DECISION DOCUMENTS for Site USTs #208 & 209

**SUBJECT: Notice to Implement Corrective Action Plan (CAP)-Part B:
Building 275, USTs 208 & 209 Site
Bultman Avenue, East of E 1st Street
Ft. Stewart, Liberty County, GA
Facility ID: 9089036*1**

SUBJECT: Corrective Action Plan (CAP)-Part B:
Building 275 UST # ~~209~~ ²⁰⁸ & 209
Fort Stewart, GA; Liberty County
Facility ID: 9089036*1

**CORRECTIVE ACTION PLAN (CAP)
PART B
UNDERGROUND STORAGE TANKS 208 and 209
FACILITY ID: 9-089036
FORT STEWART, GEORGIA**

USTs 208 AND 209
 SOUTH TRANSPORTATION
 GROUNDWATER POTENTIOMETRIC SURFACE

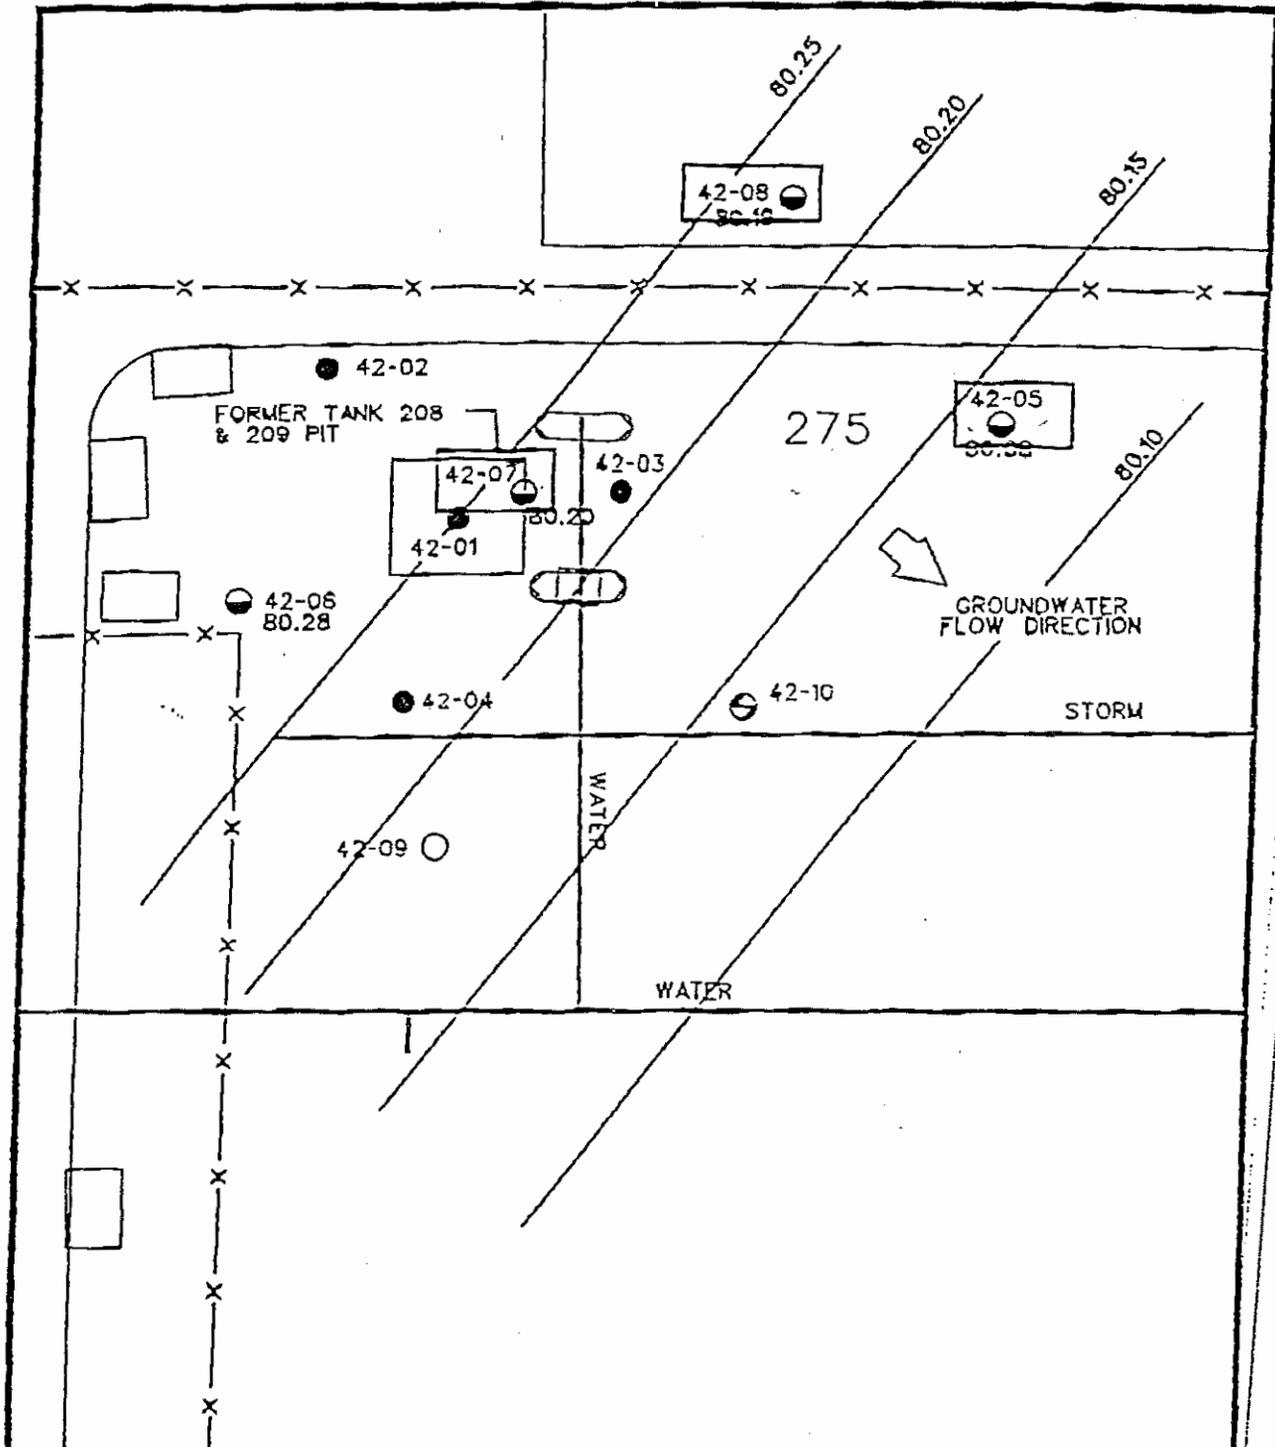
1. Evaluation of potentiometric data and groundwater analytical results from the CAP A and CAP B SI's suggests that the downgradient limit of BTEX and PAH impact has not been delineated. The analytical control used to define the isopleth interpretations is located directly adjacent and slightly downgradient of the former tank location, and at locations northeast, north, and southwest of the former tanks. However, a large gap in well coverage exists to the east of the former tanks, in the direction interpreted to be downgradient, based on potentiometric contours. Little basis therefore exists for generating the isopleths included in the CAP B, and a minimum of one and preferably two water table monitoring wells should be installed in the downgradient region (east of the former tanks) to provide monitoring points.

2. Water levels in wells across the site range from approximately four to eight feet bgs. Please provide information on depths of water and sewer line trenches at the site, and evaluate whether the utilities serve as a preferential pathway for contamination from the tank release.

Per Comment #1, Fort Stewart agrees that an additional monitoring well located east of the former tank pit will provide more data for development of potentiometric maps and will also provide a more accurate downgradient well location. This additional well will be installed as indicated on the enclosed figure. Well installation is scheduled for January 1999 and, once installed and developed, the new well (42-10) will be included in all future sampling events at this site.

Per Comment #2, a stormwater line is present in the vicinity of the former UST site and is at a depth of approximately 6½ feet below ground surface (bgs). Although groundwater is at a depth of between five and six feet bgs in this area, soil boring 42-04, located adjacent to, and upgradient of, the stormwater line, had no detects for either soil or groundwater contamination. This indicates that groundwater contamination has not reached the area downgradient and southeast of the former tank pit. Although, Fort Stewart concurs that the stormwater line has the potential to act as a preferential pathway for contamination, the location of the proposed downgradient well (downgradient of the former tank pit and upgradient of the stormwater line) will provide sufficient detection of groundwater contamination migrating towards the stormwater line.

The water line located in and around the former UST system is located at a depth of approximately two feet bgs, and was only used to serve the dispenser islands associated with the former USTs. Since the water table is between five and six feet bgs, the backfill associated with the water line would not be a preferential contamination pathway (i.e., the contaminated groundwater will remain at the soil/water interface). In addition, as indicated on the enclosed figure, there are no sewer lines in the vicinity of the former tank site.

Based on GA EPD's review comments dated August 15, 1998, Fort Stewart will install a shallow monitoring well (42-10) in January 1999 as indicated on the enclosed figure. Semi-annual monitoring will also be conducted in January 1999, constituting the second sampling event at the site (NOTE: The first semi-annual sampling event was conducted in June 1998). The first Annual Summary Report for monitoring of the site and all future monitoring will be conducted in accordance with the enclosed Milestone Schedule.

Figure A-5. Proposed Sampling Locations at USTs 208 and 209.

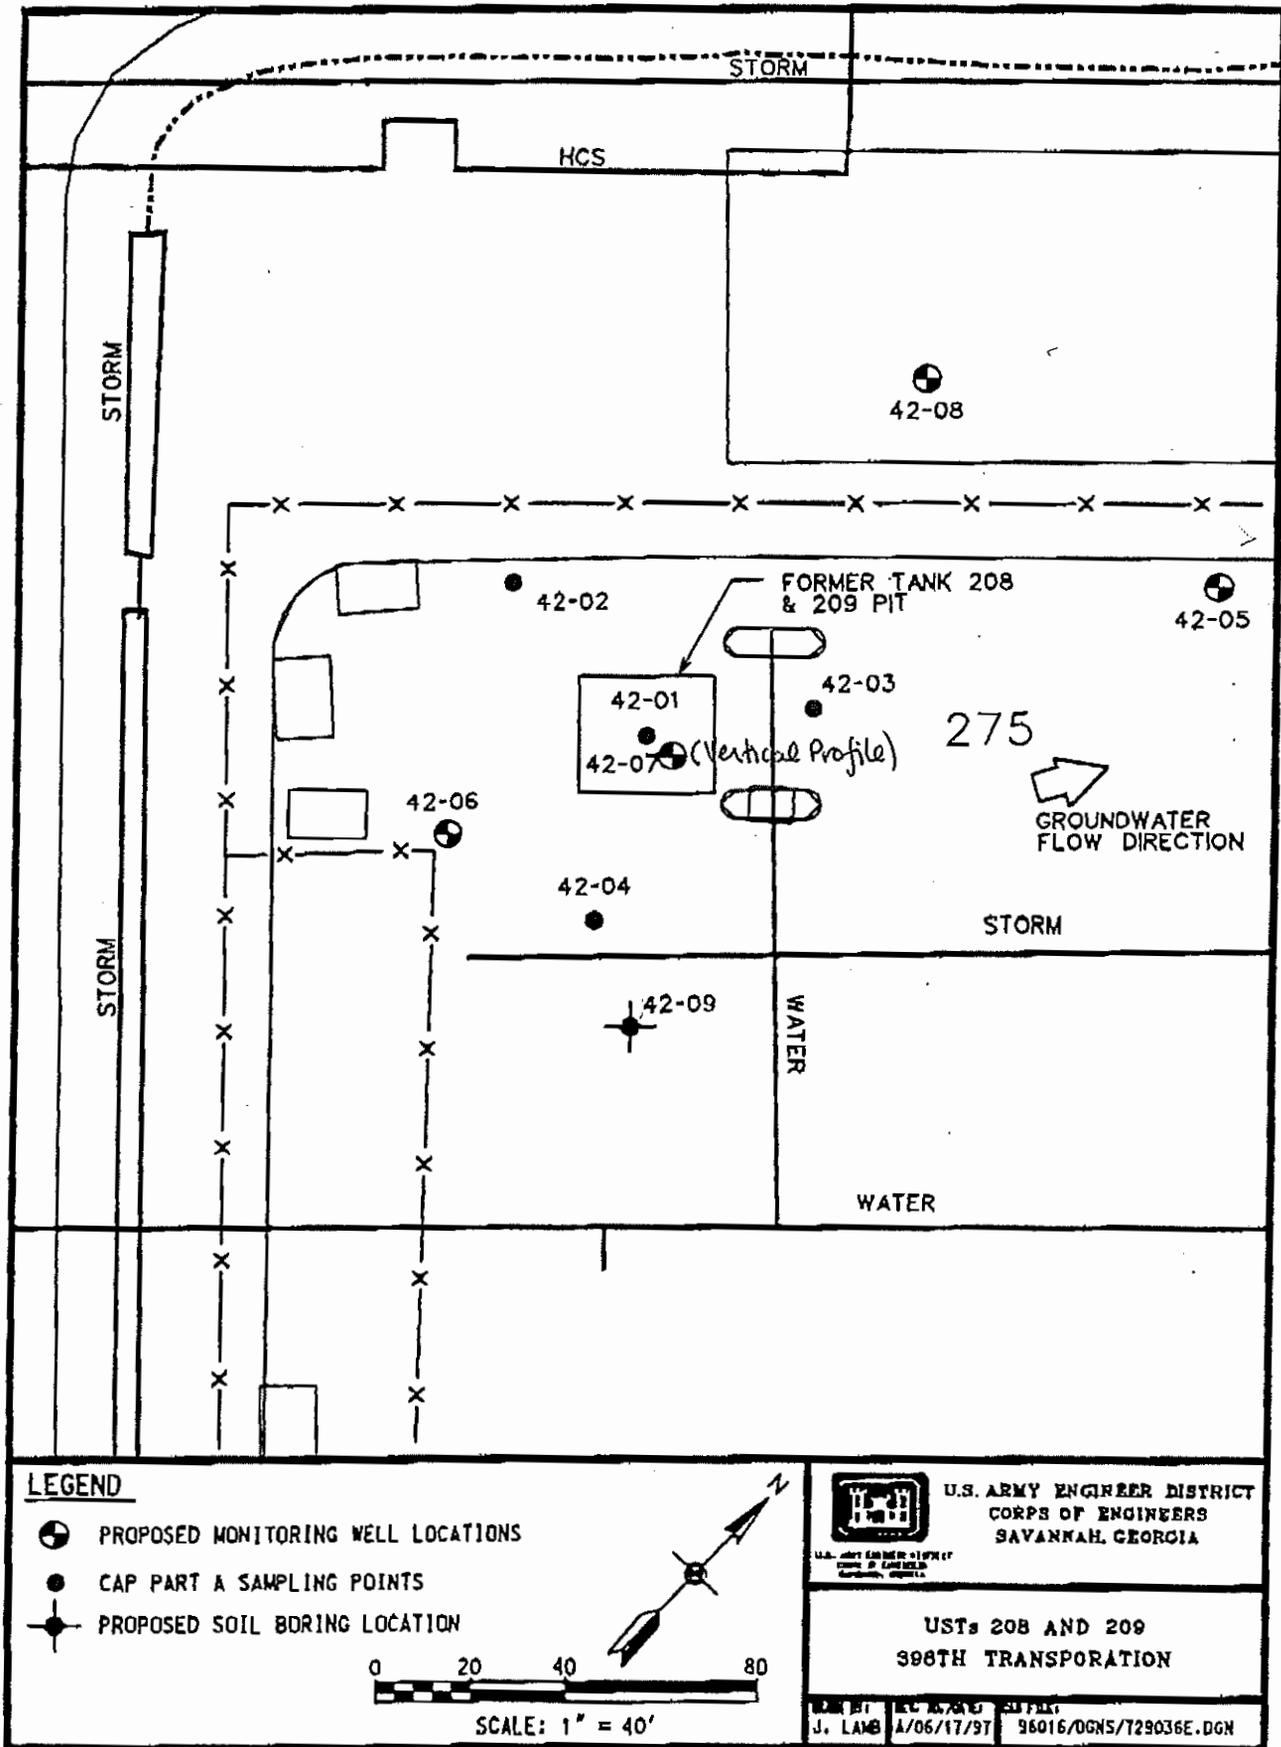
1. The CAP-Part A investigation was not sufficient to detect free product at the site since the groundwater sample in the worst case area (the tank pit) was collected with a PowerPunch sampler. Please install the proposed monitoring wells with an equal portion of the screen above and below the water table. This will allow detection of free product if it exists.

Comment No.	GA USTMP Comment	Response to Comment
1	<p>The CAP-Part A was not sufficient to detect free product at the site since the groundwater sample in the worst case area (tank pit) was collected with a PowerPunch sampler. Please install the propose monitoring wells with an equal portion of the screen above and below the water table. This will allow detection of free product, if it exists.</p>	<p>Wells were installed 13-23 July. The temporary wells installed during the CAP-Part A were capable of detecting the existence of free product as discussed with GA EPD during the 13 and 14 August. The permanent monitoring wells were also installed in accordance with the Corps of Engineer approved Workplan and EM 1110-1-4000 (provided to GA EPD during visit) and the wells are capable of detecting free product.</p>
